Site Instruction

SI 24

PROJECT : Hampton Manor
PROJECT No : 1136.13
DATE : August 14, 2018

Title: Removal of Insulation behind Precast

SECTION DETAIL @ GROUND PRECAST PANEL 4
SCALE - 1/5 A652

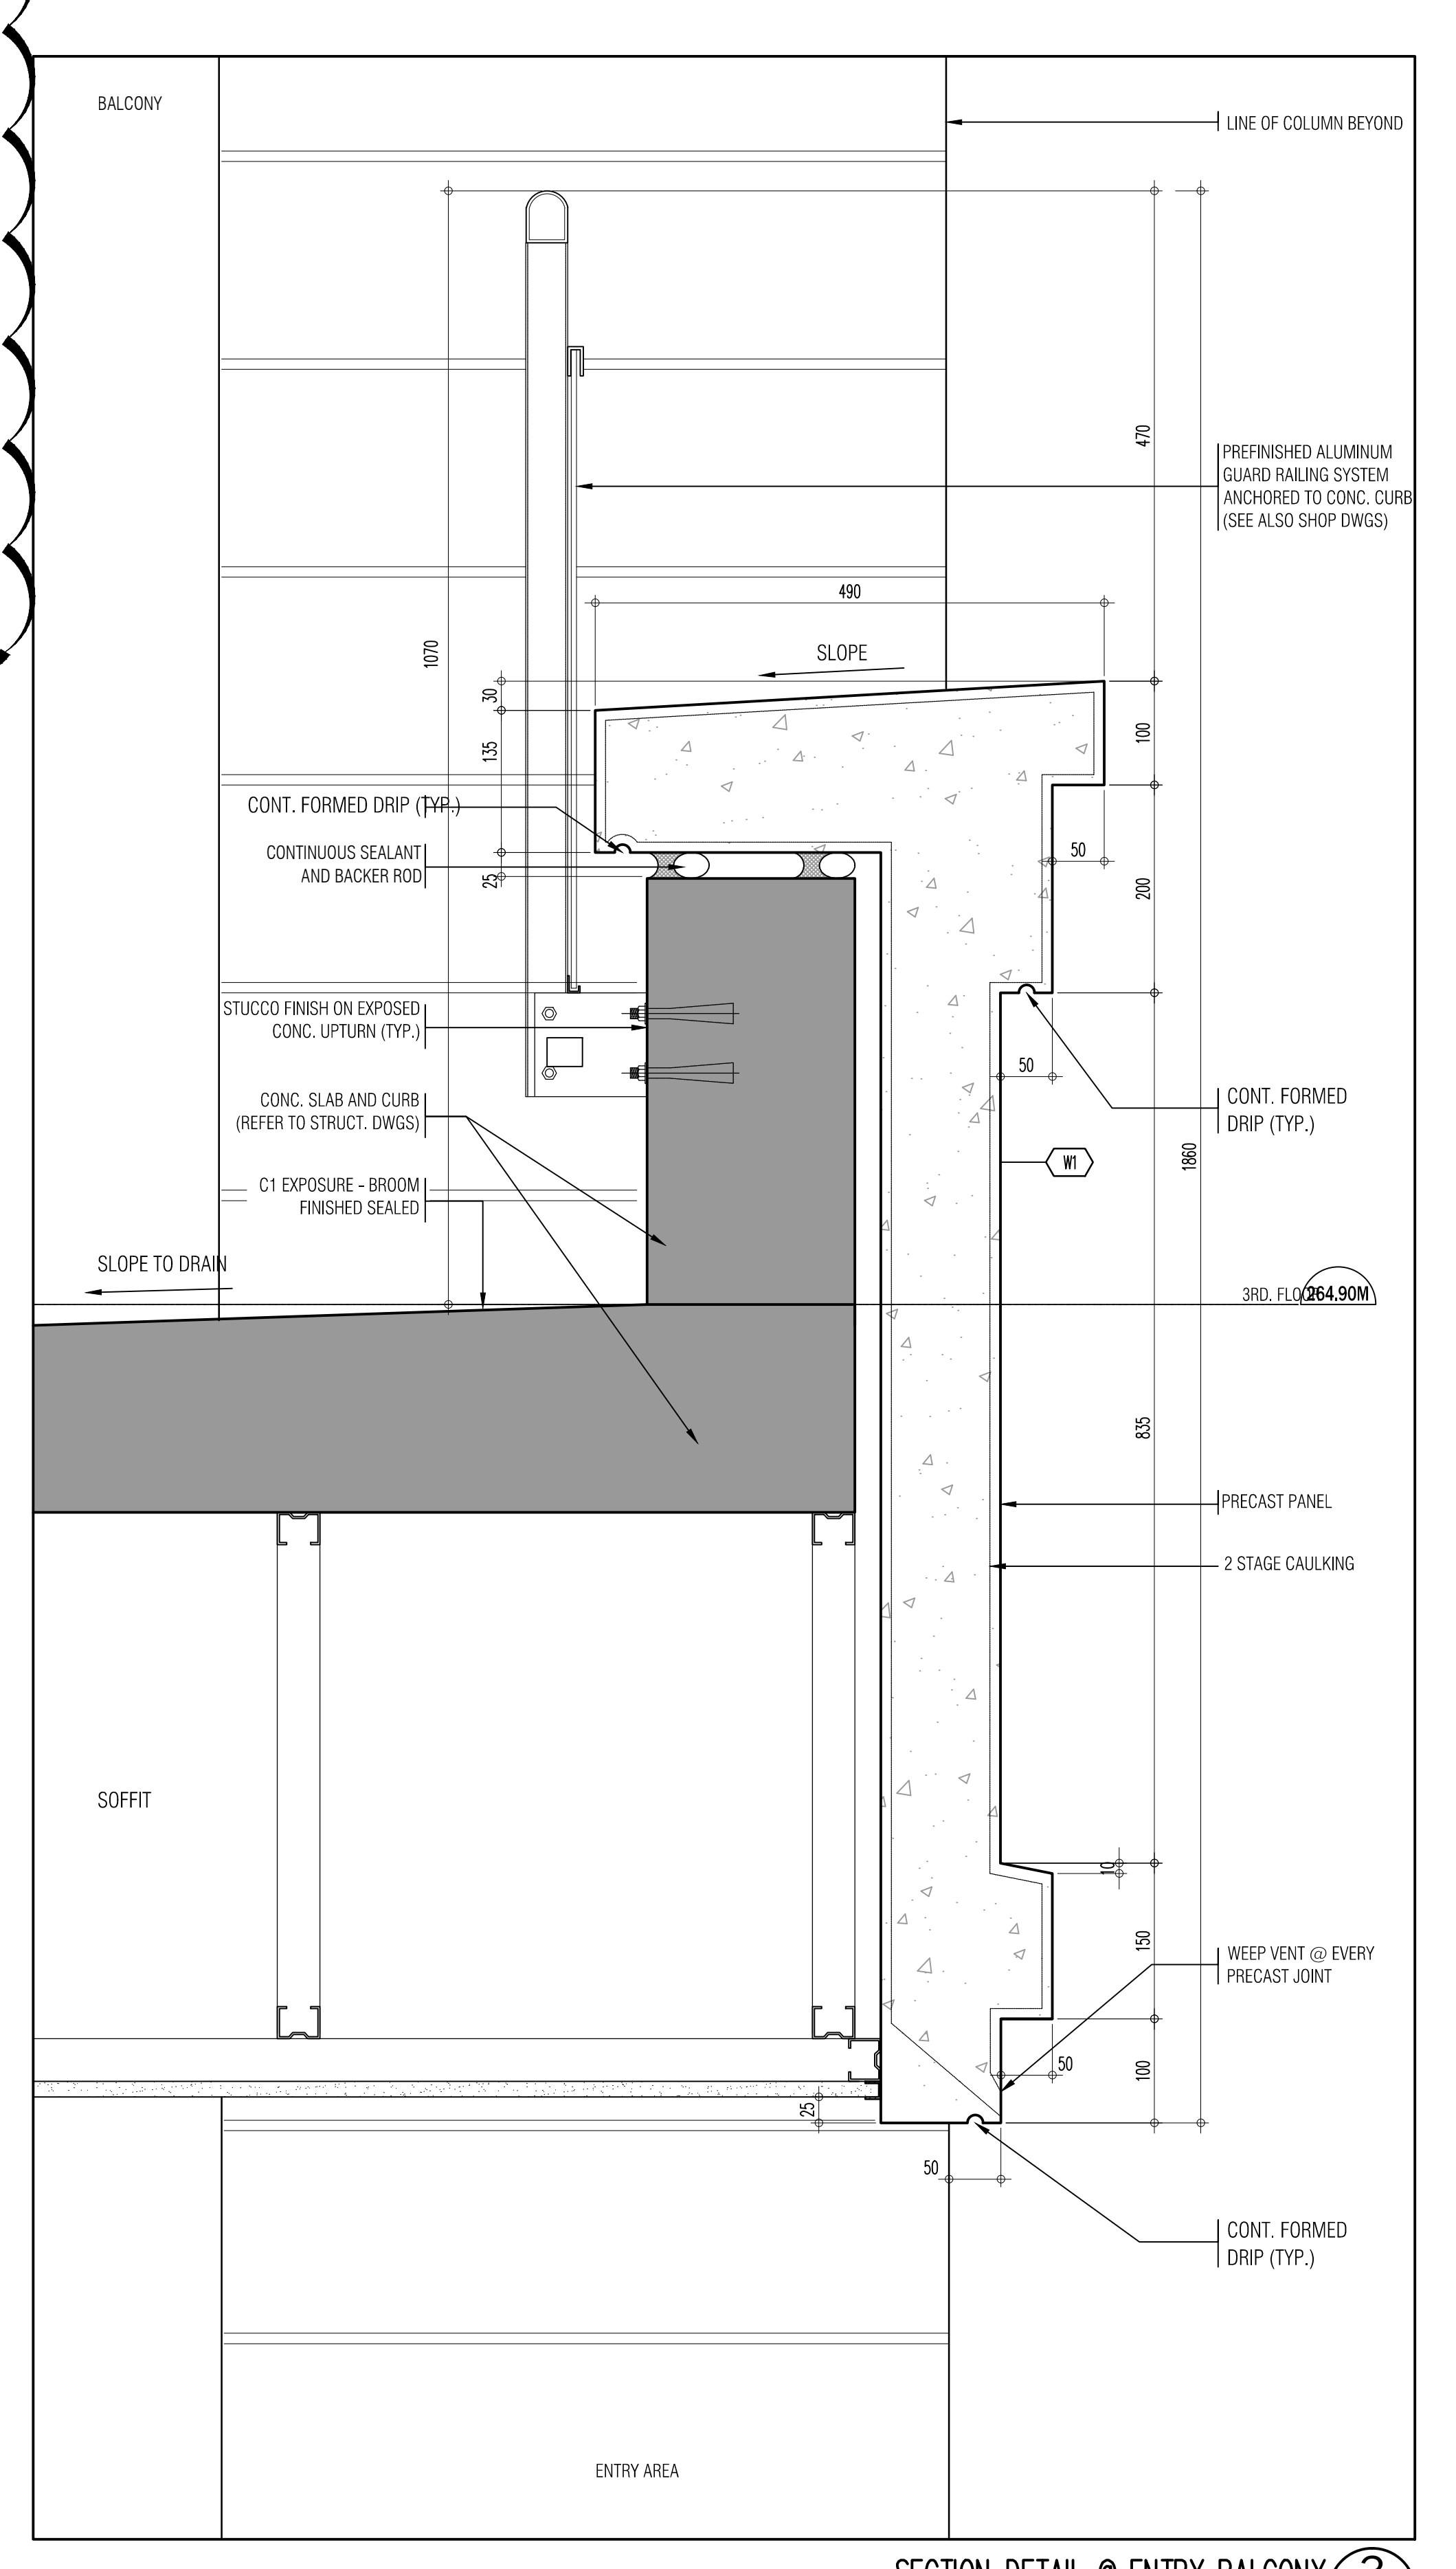
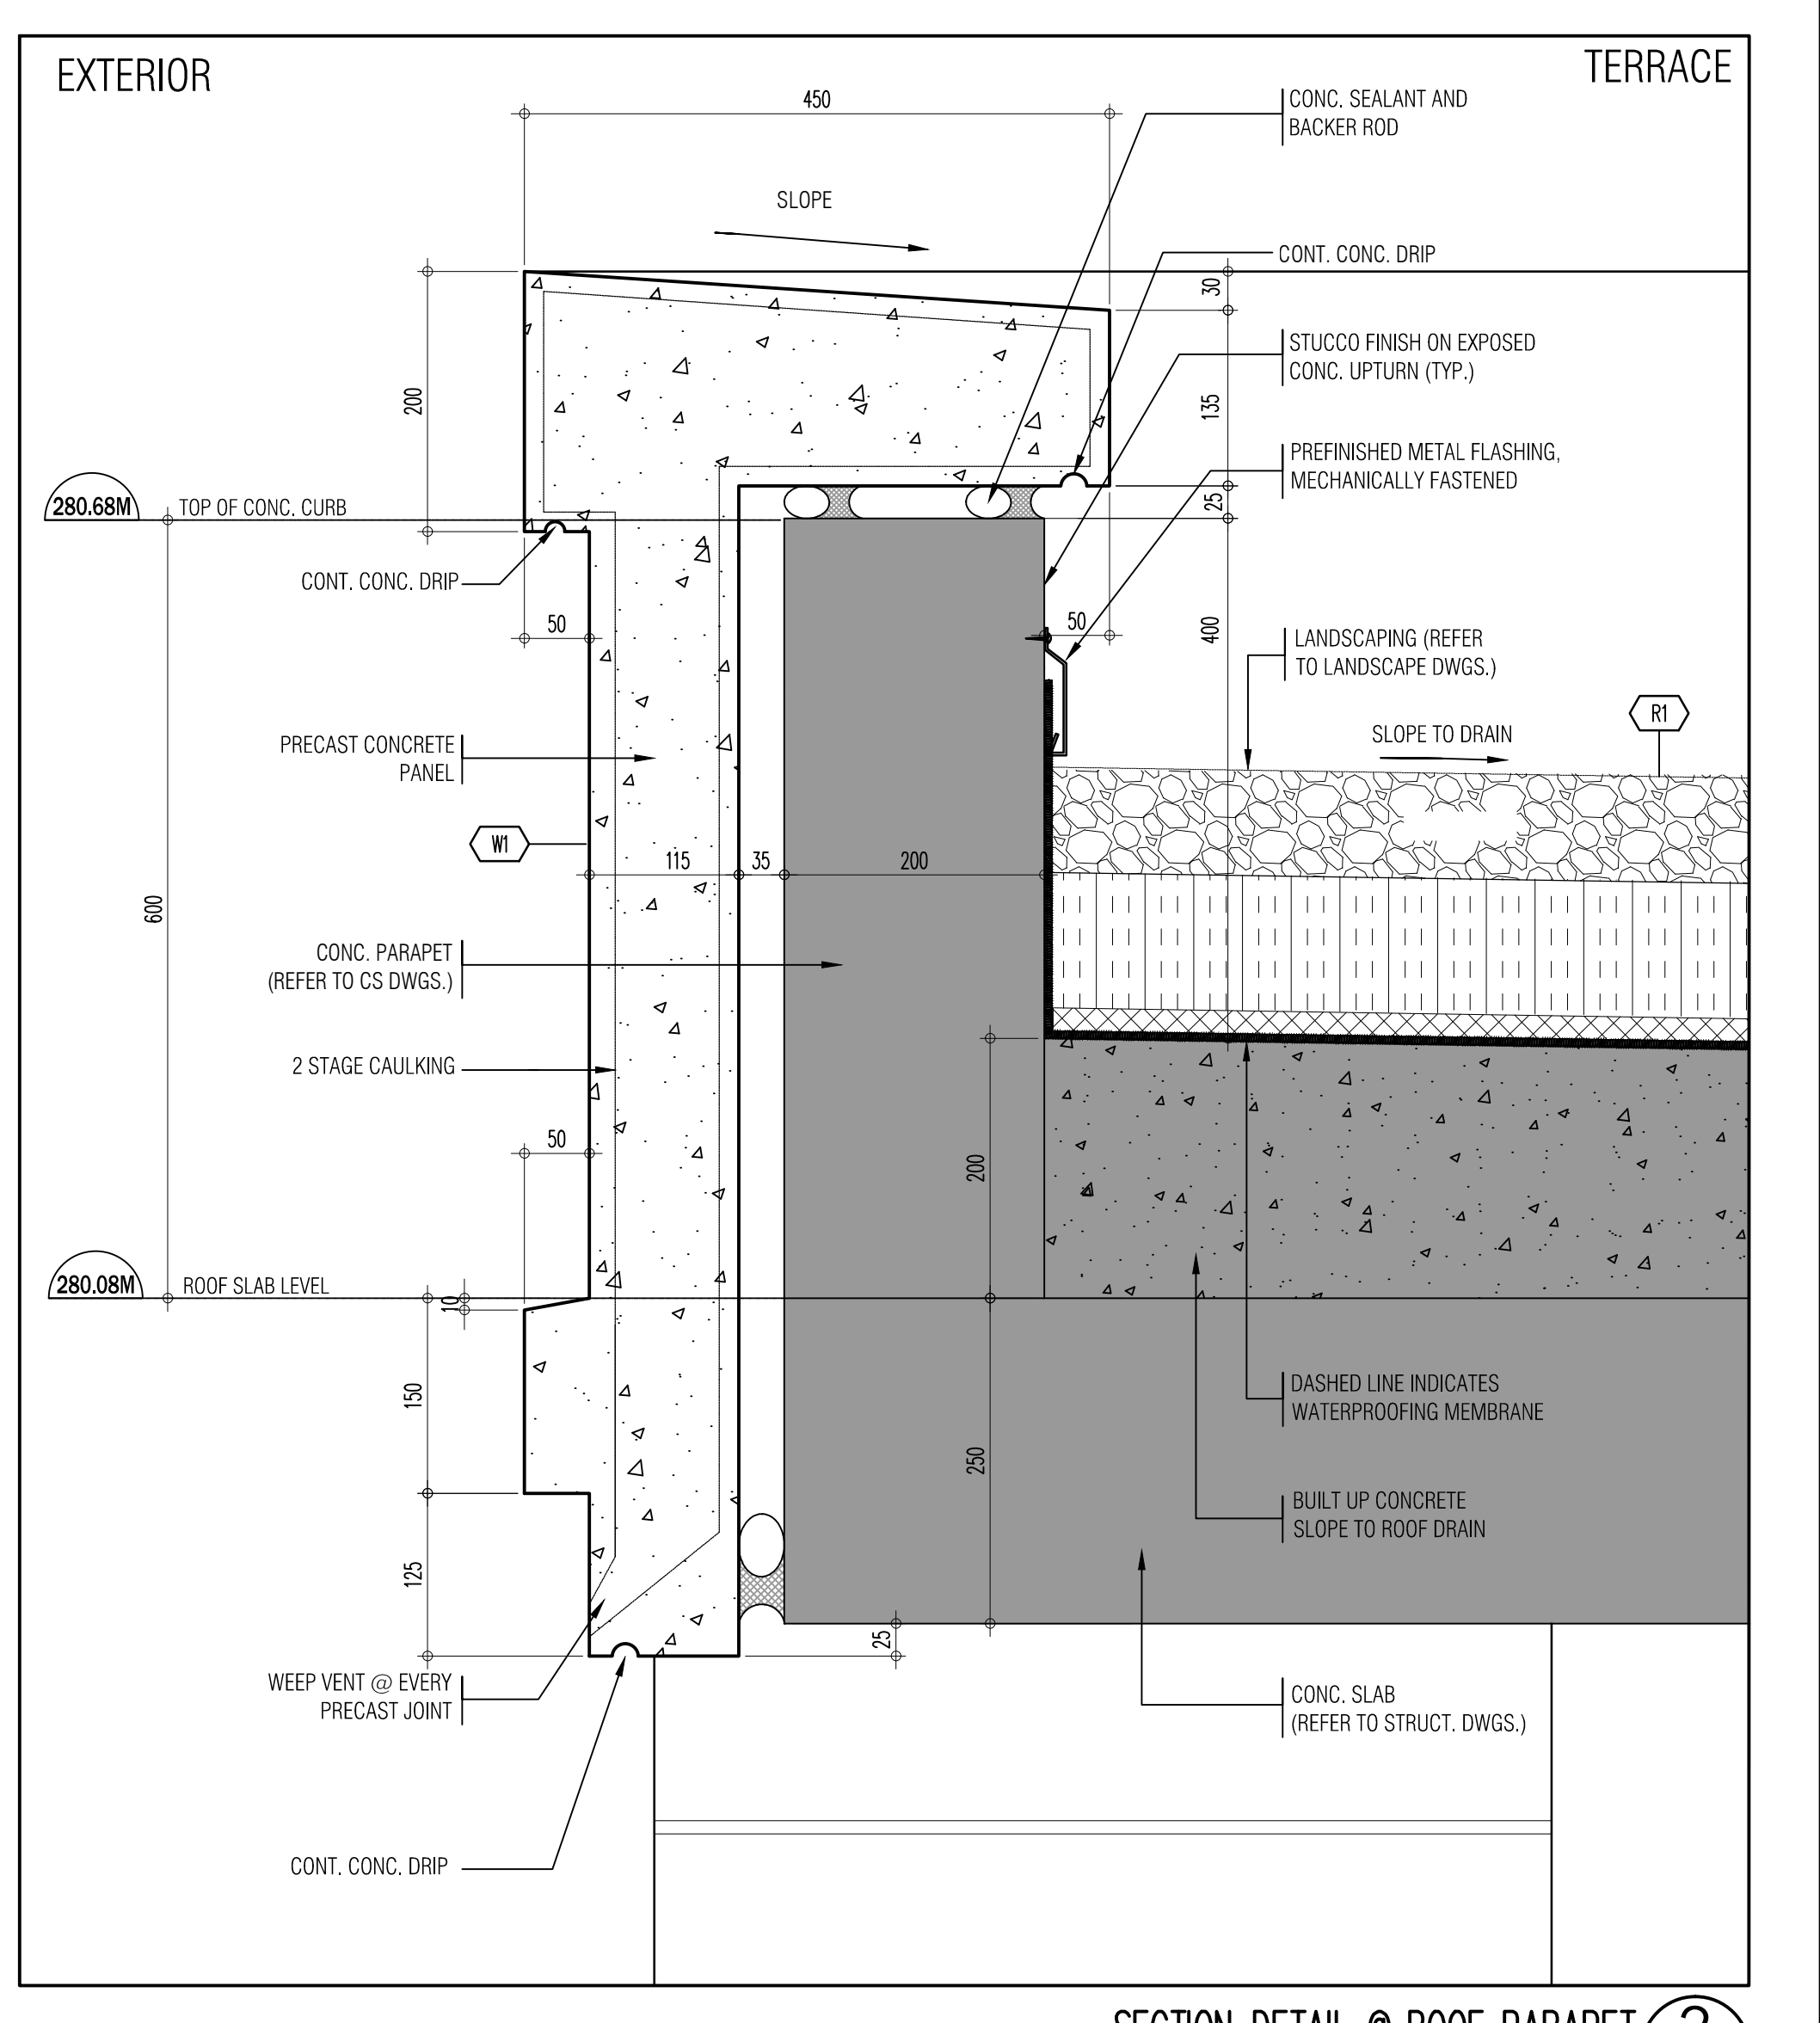
- Removal of insulation behind precast at terraces and roof.
